STRUCTURAL REPORT

MEXICO BEACH PIER

RE: City of Mexico Beach Fishing Pier
Our Project # 001.088

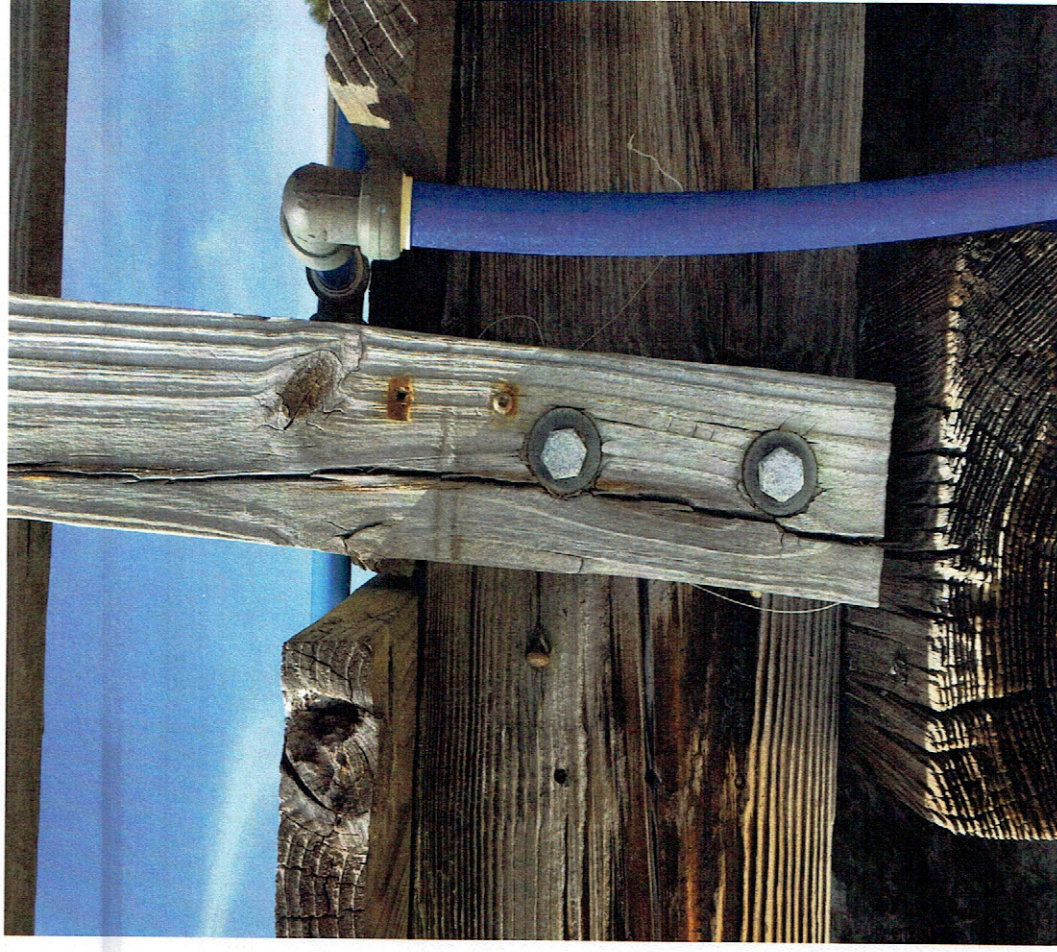
1. Many of the hand rails and their support posts are damaged or loose and need attention (reference Photograph D attached).
2. There is evidence of pile settlement and misalignment which has resulted in an un-even deck surface (reference Photograph E attached). This detracts from the overall appearance, however it does not concern us from a structural standpoint.

3. Many of the timber beams, bracing and connectors that comprise the original portion of the pier are, understandably, deteriorated due to their advanced age and the harsh environment to which they have been subjected. Some beams are warped, checked or cracked many of the connectors (bolts, brackets) are missing or badly corroded (reference Photograph F attached) and some of the bracing is broken. It is evident that quite a bit of repair work has taken place, especially on the pilings; crutch piles where they are rotten at the ground line and shim plates (reference Photograph G attached) either to compensate for settlement or to replace a rotted top section of pile. Luckily though, the original design/construction was so conservative that even in its deteriorated condition we believe it is structurally adequate for the time being. The timber beams, pilings and connectors that comprise the two pier extensions, except as noted below, are still in good shape.

4. The fiberglass pilings that support the "T" section have a plastic coating that protects the fiberglass from ultra violet light (reference Photograph I attached). This coating has delaminated from the pilings and left the fiberglass exposed. Also, some of the steel bracing and connectors are rusted (reference Photograph H attached). These issues need attention, but are not urgent or critical at this time.

5. Several of the piling at the shoreline are completely rotted thru and were repaired in a shoddy manner, in one case, the middle support piling is missing (reference Photograph J attached). This is a cause for alarm and we recommend immediate repairs.

Replace the missing pile and the ones that were poorly repaired. At least three section of the pier (45 ft.±) will have to be temporarily removed and set aside in order to conduct this work. These sections can be re-used if handled carefully.

- Replace damaged or rotted hand rails and posts, re-tighten and or replace loose nuts and bolts.
- Replace broken bracing members
- Recoat the fiberglass pilings (paint them).
